FINAL
ENVIRONMENTAL IMPACT STATEMENT

Village at Po'ipū

Accepting Authority,
State of Hawai'i Land Use Commission
Docket No. A05-761
Eric A. Knudsen Trust

November 2006

Figure 15
 U.S. Fish and Wildlife Service
 Critical Habitat Areas

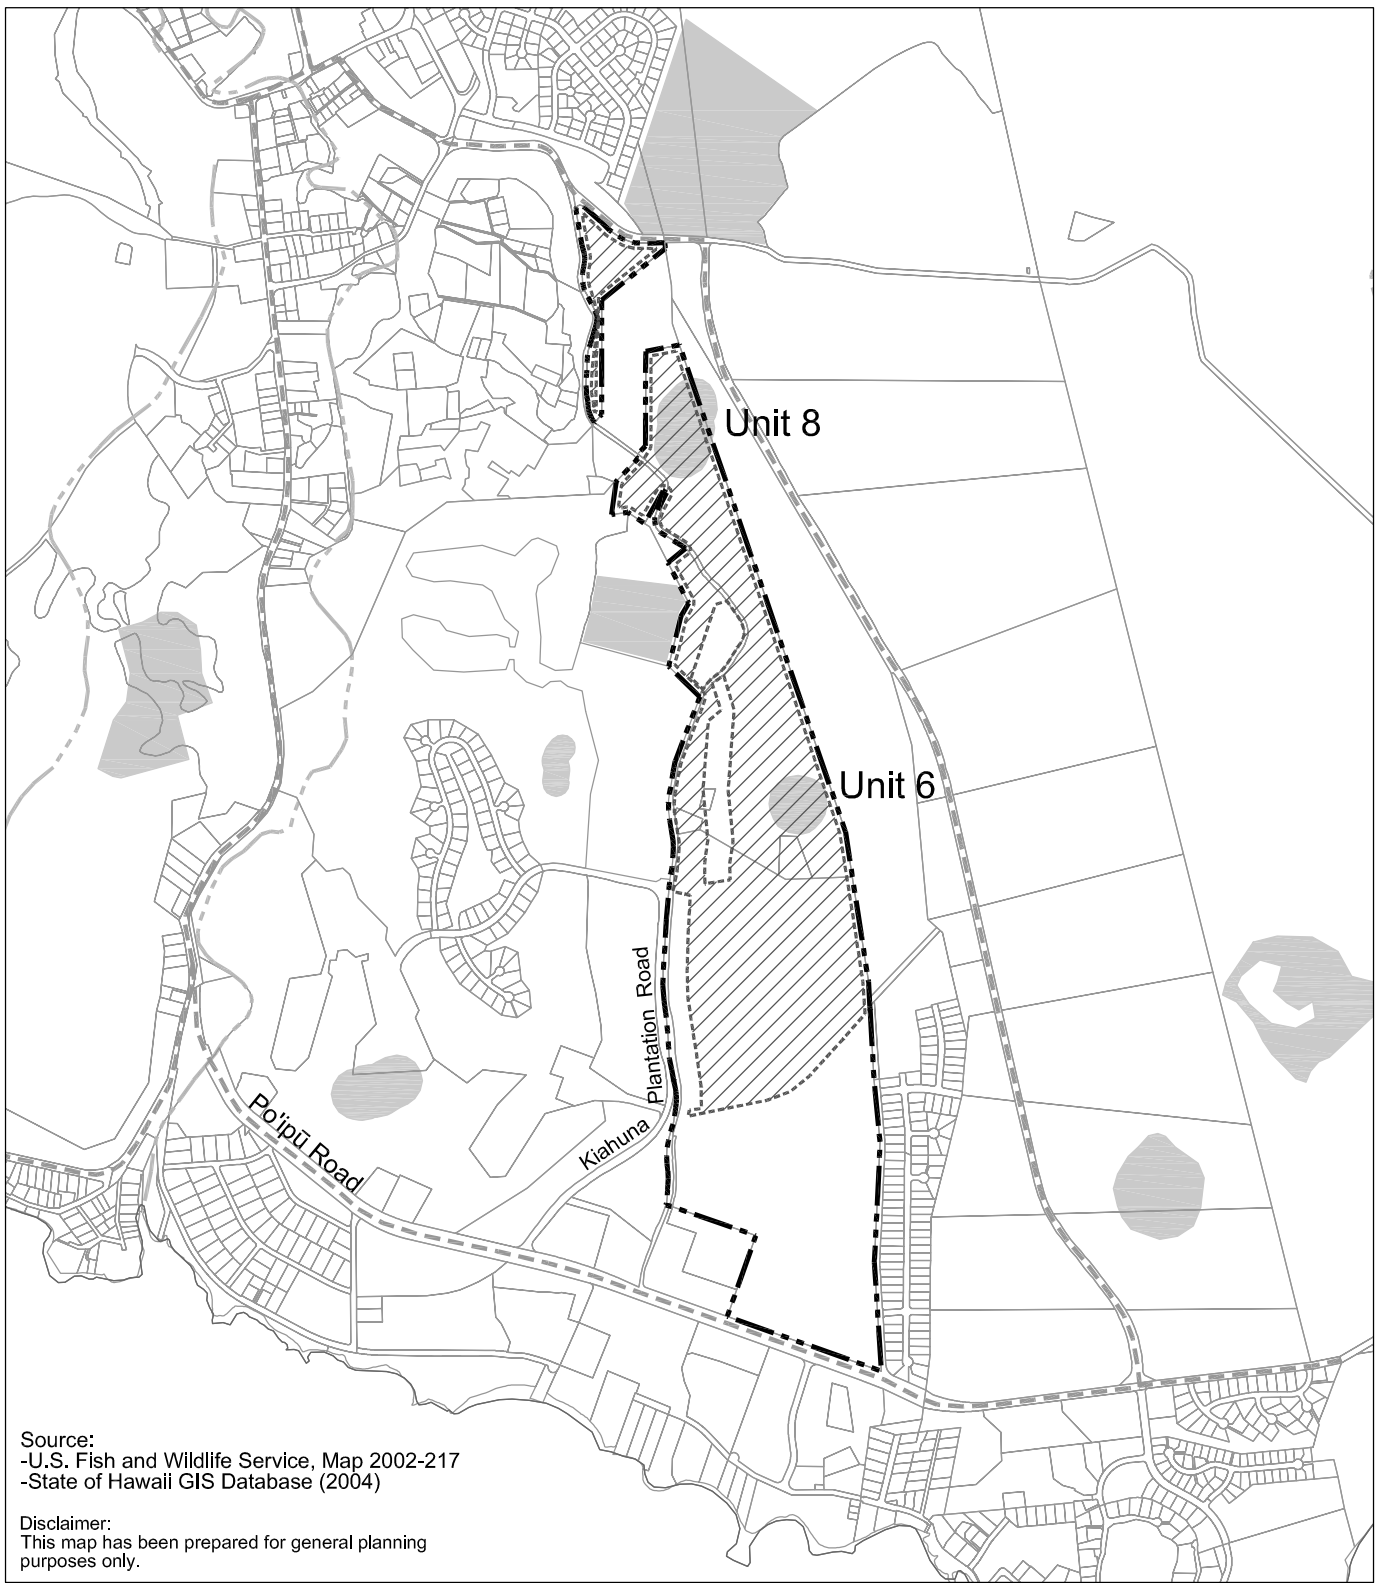
- 5) We note that the U.S. Fish and Wildlife Service has designated two areas within the Village at Poipu project site as "critical habitats" for the endangered Kauai cave wolf spider and amphipod. A 50-foot buffer within which no development will occur is planned to protect these habitats, which will be preserved as archaeological sites. Petitioner intends to landscape the areas with native plants to improve possible habitat conditions for these endangered invertebrate species. To the extent that their existence within the designated areas is currently unknown, we believe that consideration should be given to conducting a survey before proceeding any further with the entitlement process to (i) confirm whether these species are, in fact, present in the designated areas as well as in other portions of the petition area; (ii) determine the extent to which they will be affected by the proposed development; and (iii) develop the appropriate actions to mitigate any potential impacts. Until then, we believe that this matter should be identified as an unresolved issue in the Final EIS.

Response: The archaeological inventory survey prepared for the project site in 1991 delineated the full extent of the lava tubes and this is shown in Figures 3 and 16 of the Draft EIS. The critical habitat unit areas as shown in Figure 15 were established by the US Fish and Wildlife Service (USFWS). Fifty-foot buffers will be provided around the delineated lava tubes as shown in the conceptual master plan for the project and will be protected as archaeological preserves in which no buildings will be constructed. In addition, native plants will be planted within these areas to improve potential habitat conditions for the two endangered species.

Figure 16
 Archaeological Sites

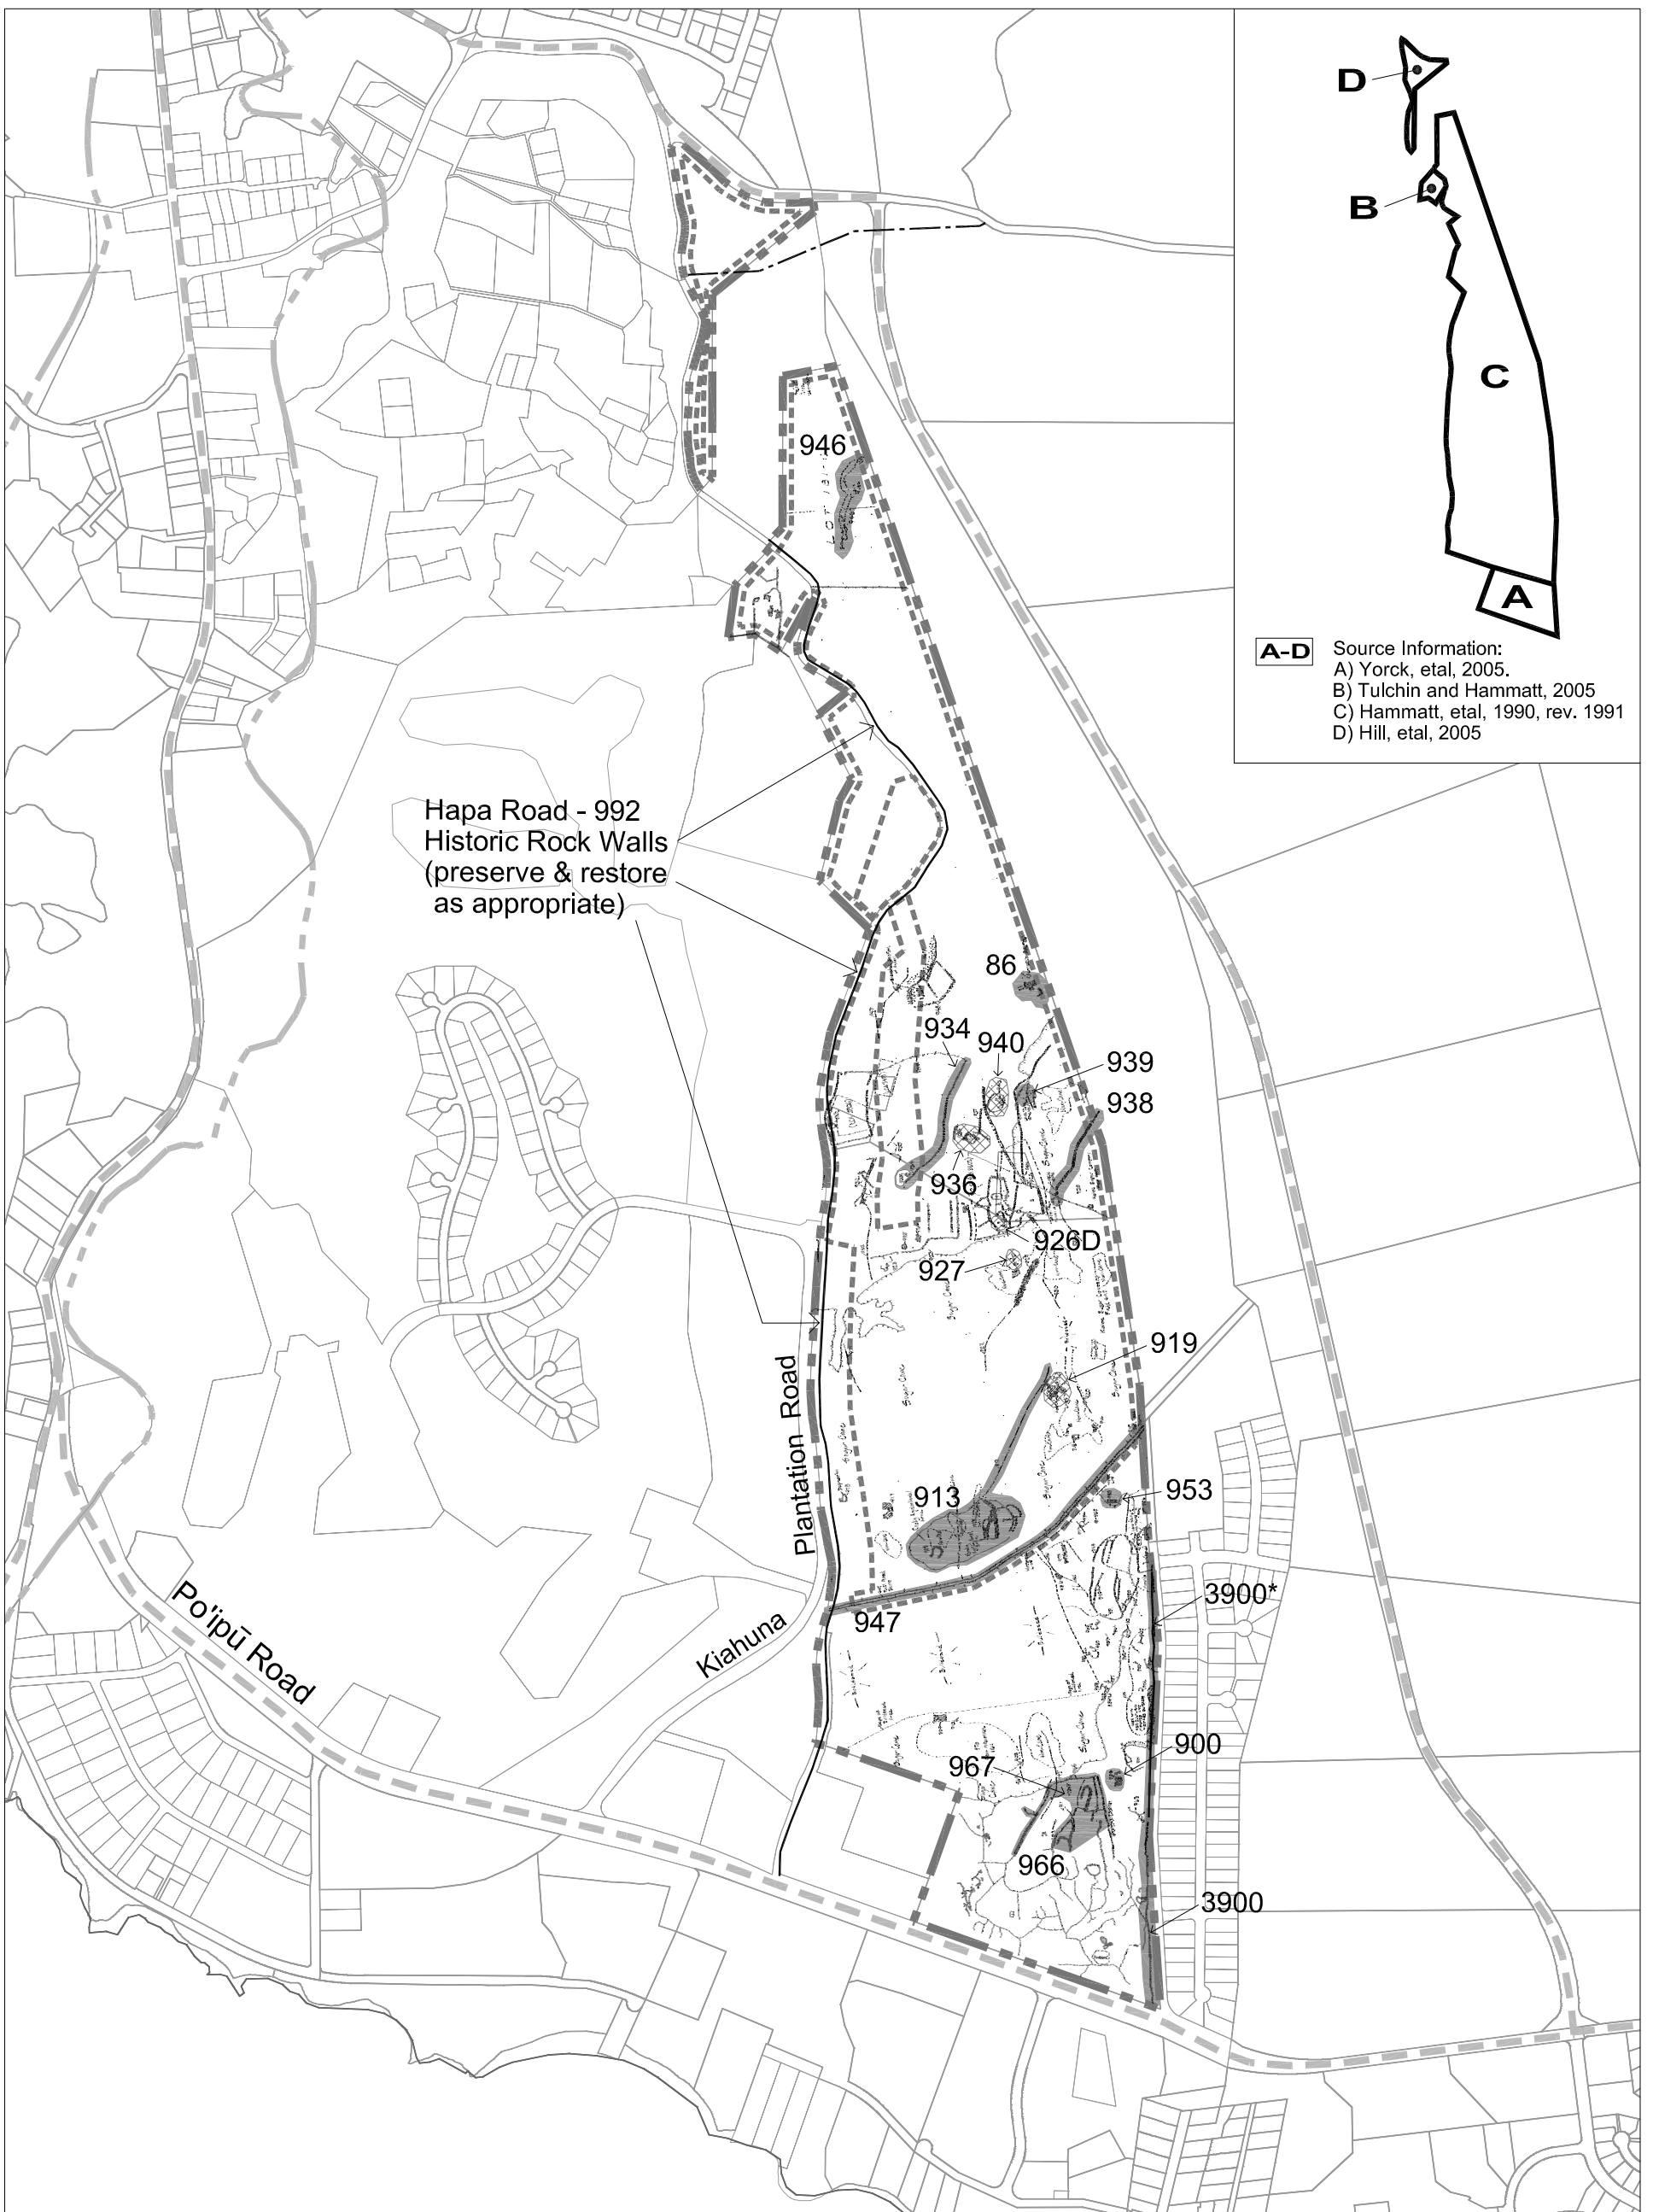
- 6) We strongly suggest that the information in section 4.1, Archaeological and Historic Resources, be supplemented with a table to clearly highlight the findings and recommendations of each of the various inventory surveys

Hapa Road will be improved as a pedestrian and bicycle path as mandated by the County of Kaua'i. The historic rock walls will be preserved in place where they are in good condition and restored where they have collapsed or have been damaged by stone robbing. Section 4.1 of the Draft EIS provides an expanded analysis of Hapa Road and its historic rock walls and has been added to Figure 16 which has been enlarged for improved legibility.

Figure 17
CIVIL DEFENSE
SIREN LOCATIONS
CONCEPTUAL MASTER PLAN
Village at Po'ipū

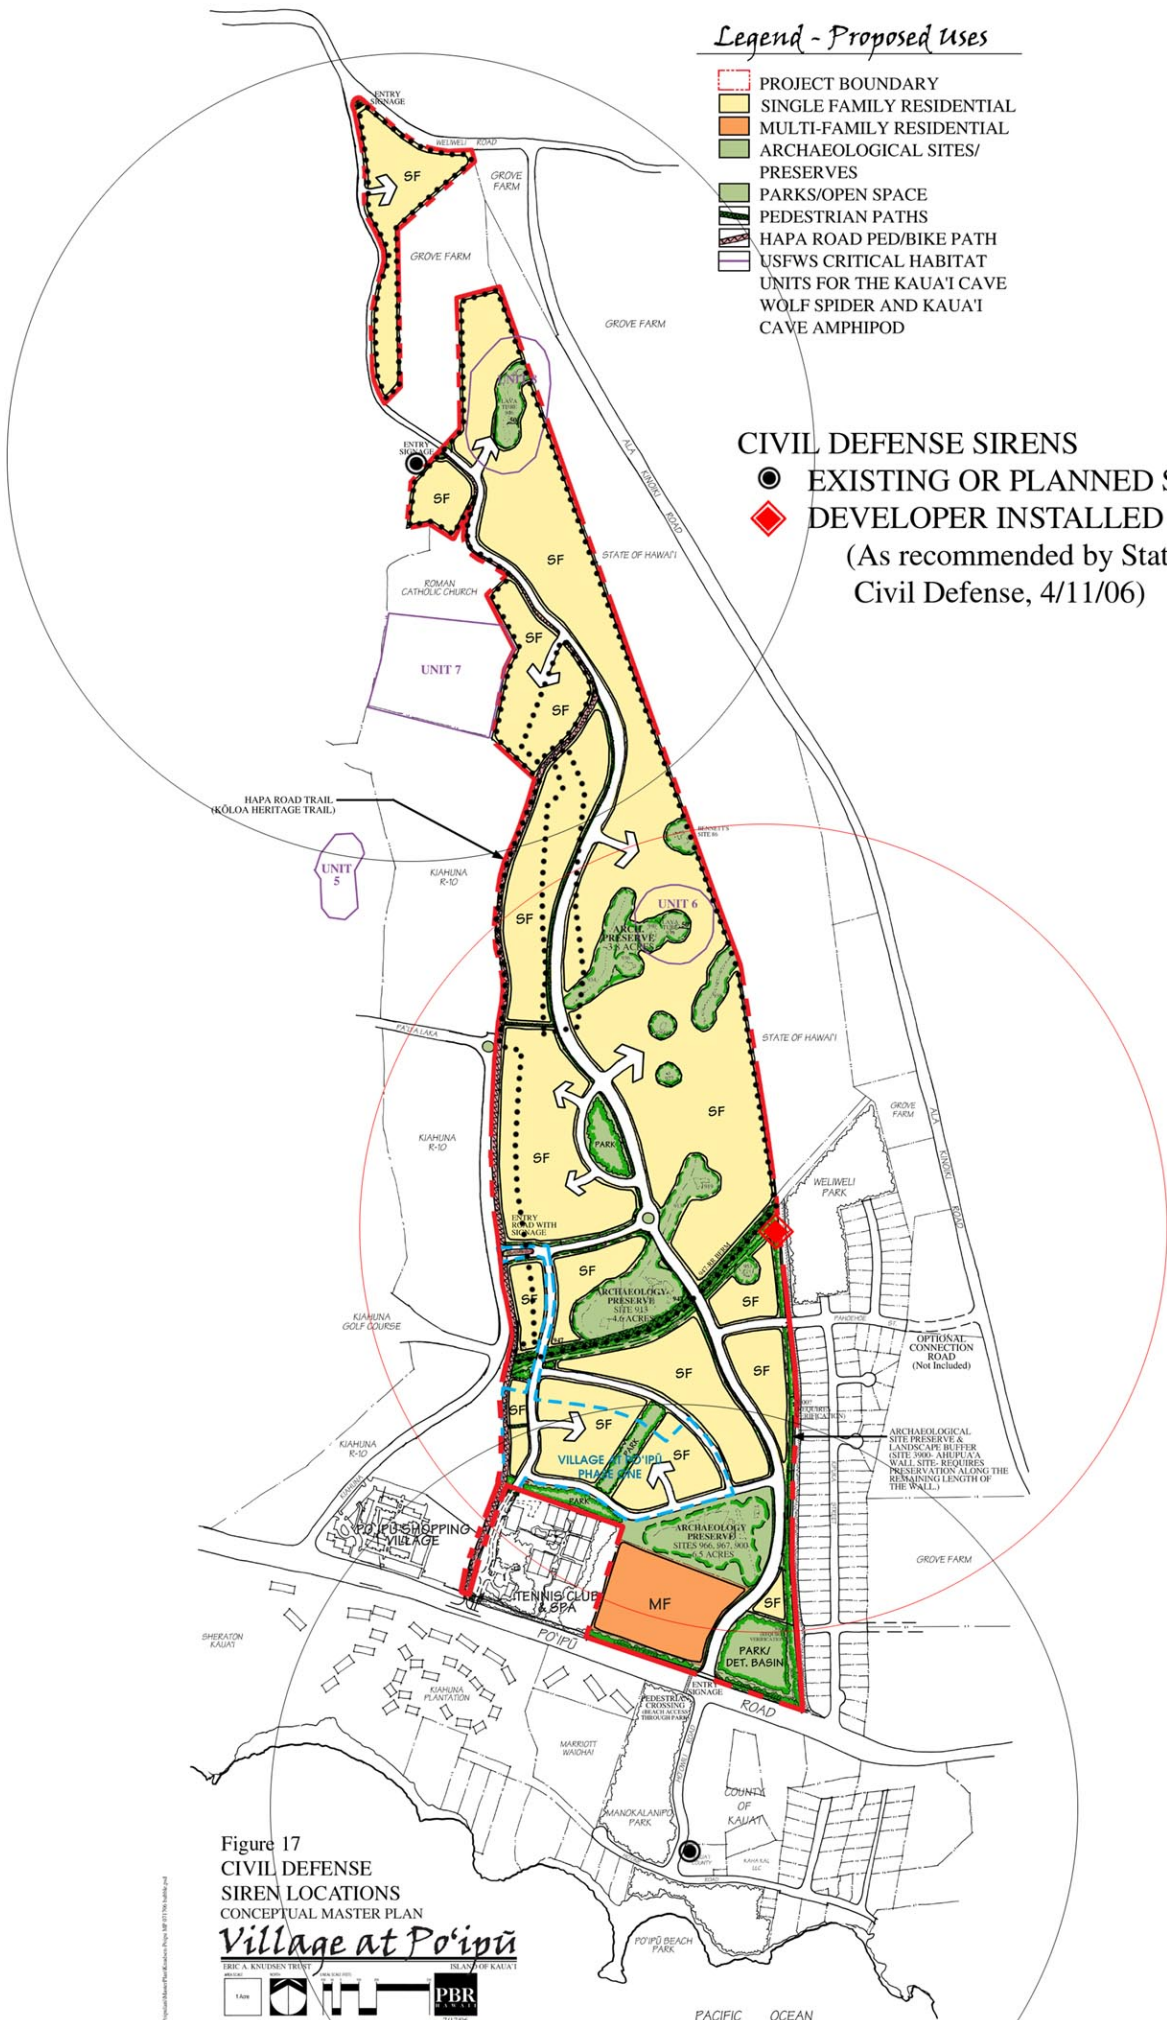
Thank you for the opportunity to comment on this Draft Environmental Impact Statement (DEIS). Having reviewed the DEIS, it is requested that the developer install a solar powered 119 Dbc siren near Weliweli Park and the berm as shown in red on enclosed Figure 3.

The increase in the number of residential units and population housed in the area caused by the development of the proposed project and petition area requires additional civil defense facilities for the area. The State Civil Defense recommends the installation of a solar powered 119 dBc siren near Weliweli Park and the railroad berm as shown in Figure 17. This recommendation is consistent with the requirements for the petition area as well since the same physical project area would need to be served by Civil Defense regardless if the additional 98 units are permitted or not. The applicant will comply with this recommendation and install the siren as proposed.
